TEMPORARY ABANDONMENT WELL APPLICATION

October 12, 2023

Re: Temporary Abandonment
API 15-195-21143-00-00
STRUSS 23-144
SW/4 Sec.23-11S-24W
Trego County, Kansas

Acoustic Test

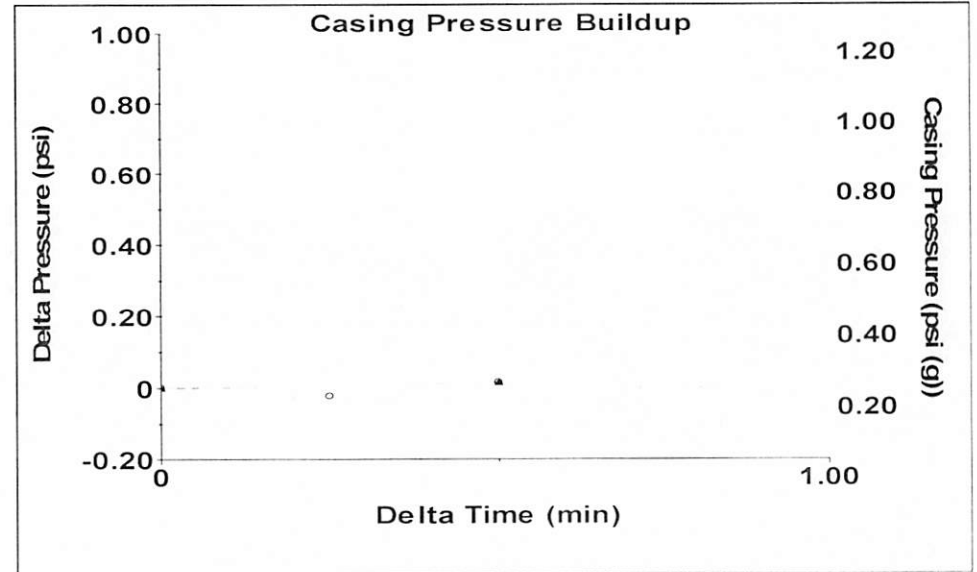
Your application for Temporary Abandonment (TA) for the above-listed well is denied for the following reasons(s):

High Fluid Level

Pursuant to K.A.R. 82-3-111, the well must be plugged, or returned to service, or obtain temporary abandonment status by 11/11/2023.
